The Applicant is also proposing flexibility with the following standards:

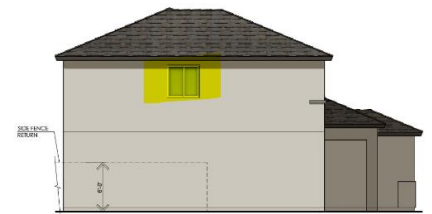
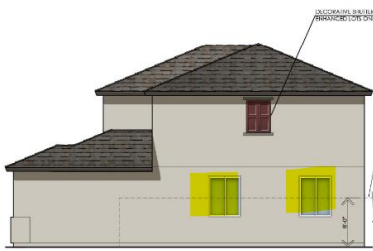
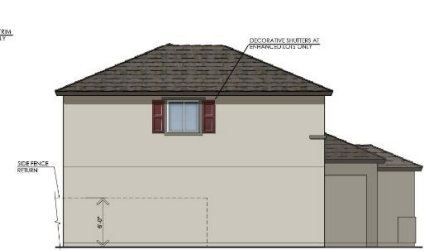
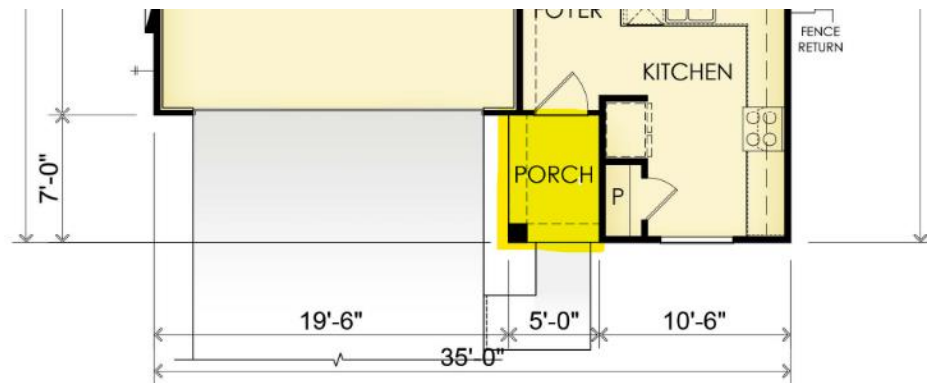
Analysis: Per the municipal code section above, trim at least two inches in depth shall be provided around all windows, or windows shall be recessed at least two inches from the plane of the surrounding exterior wall. The project does not provide trim around all windows, see below highlighted elevations. For this reason, the applicant requests flexible development standards per the code.

First Floor Plan

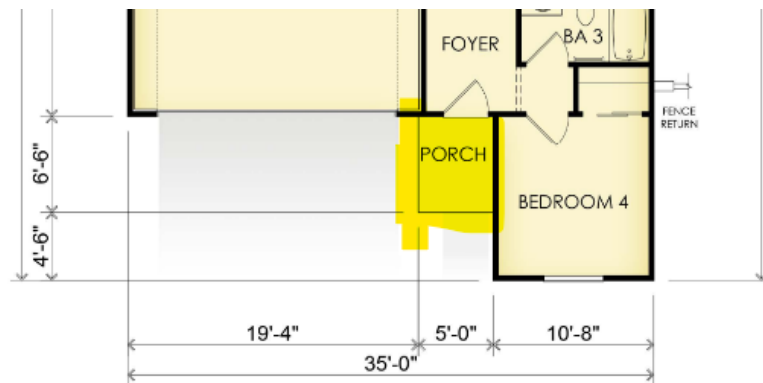
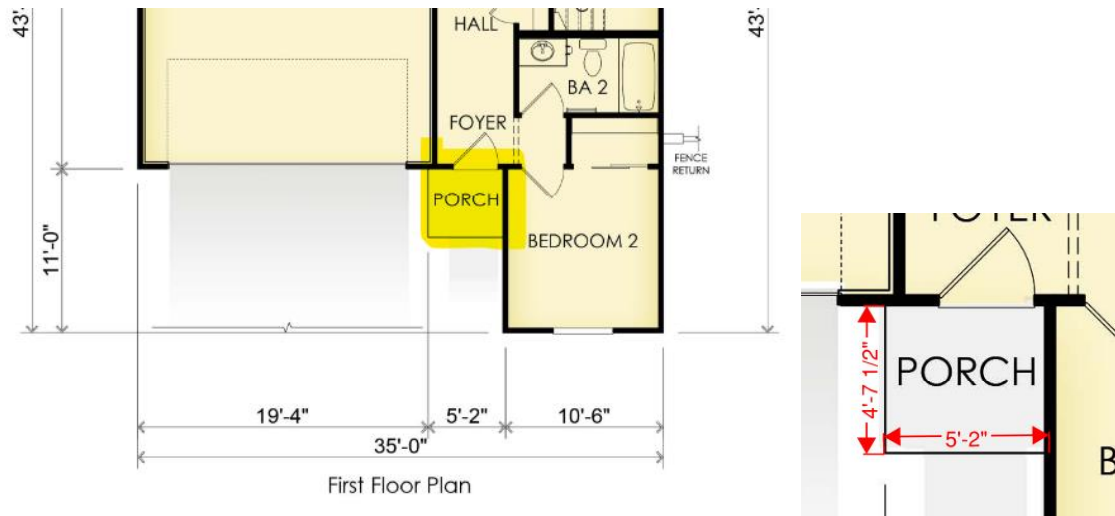
Analysis: Per the municipal code section above, building entries shall be 36 SF. The below highlighted building entries range from 22SF – 32.5 SF - 35 SF. For this reason, the applicant requests flexible development standards per the code.

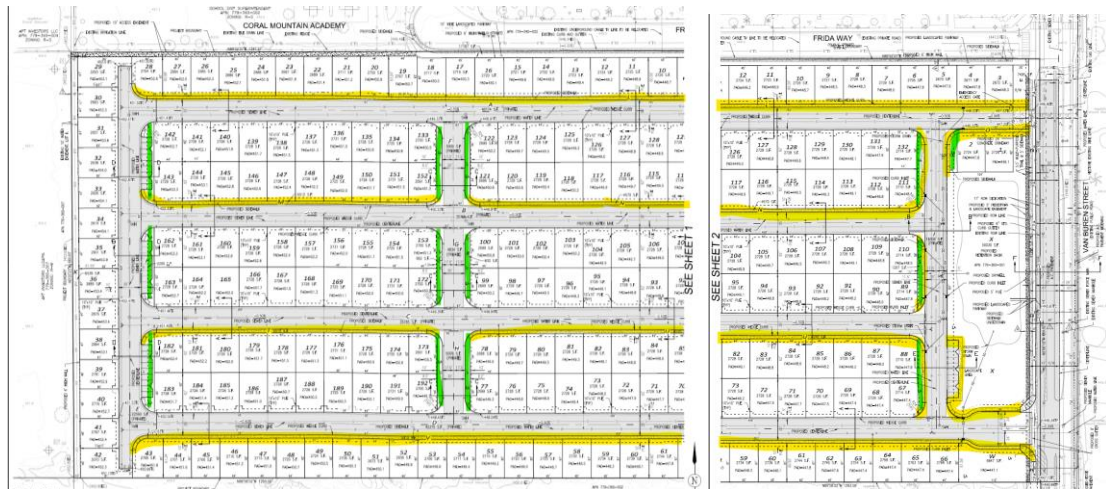
Per the municipal code section above, the applicant is required to provide the following elements: Equestrian and agricultural themed improvements including equestrian rail fencing, agrarian lighting, agrarian signage, 10-foot-wide decomposed granite multi-purpose trail and date palms planted twenty (20) feet on center shall be incorporated with new development along Avenue 50, Avenue 52, Van Buren Street and Calhoun Street South of Avenue 50. The project does provide an equestrian fence design, however does not meet the specific requirements above. The equestrian design provided in the plans provides a 5' 6" decomposed granite trail instead of a 10-foot granite trail. The project also does not provide date palms. For this reason, the applicant requests flexible development standards per the code.
